| Re: Service Campaign Notification Model 907 (Sprinter) Model Year 2021 Retrofit Door Control Module | DATE: July, 2022 |

Campaign No. 2022060004 July, 2022

SUBJECT: **Model 907 Model Year 2021**
Retrofit Door Control Module

D72.29-1129-76

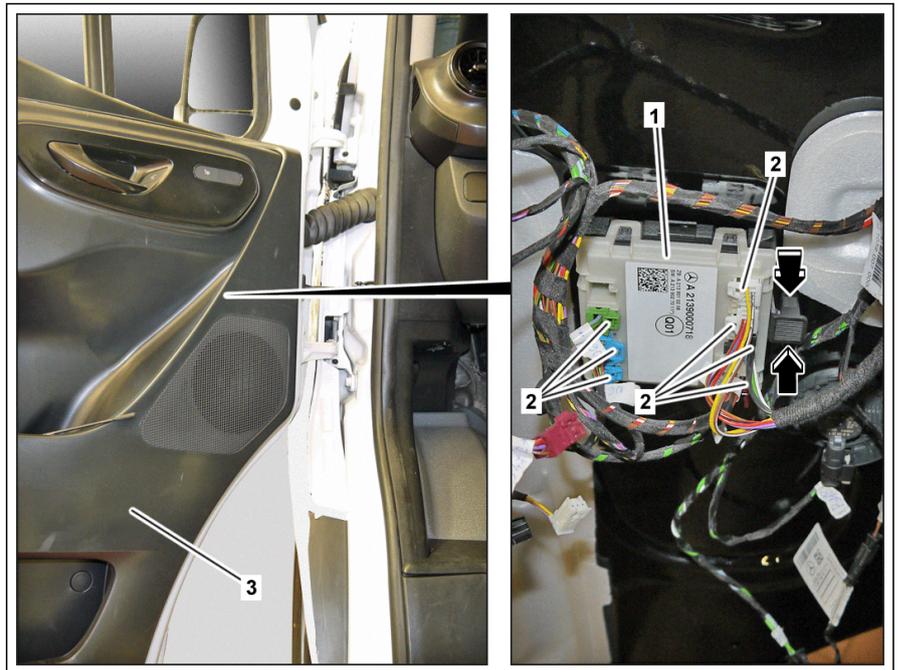
| Category | Op. no. | Operation text | Time | Acc. no. | Code |
|----------|---------|---|---------|-----------|---------------|
| L | 02 0363 | Operations: Retrofit control units of front doors | 1.5 hrs | 06 991 08 | VS3TURST E |

Shown on left front door

- 1 Control unit
- 2 Electrical connectors
- 3 Door trim

| 3 | Retrofit control units (1) of both front doors. | <p> Clip control units (1) into holders and lock (arrows).</p> | AR72.29-D-1001TS |
| 4 | Connect electrical connectors (2). | <p> The number of electrical connections (2) may vary depending on vehicle equipment.</p> | |
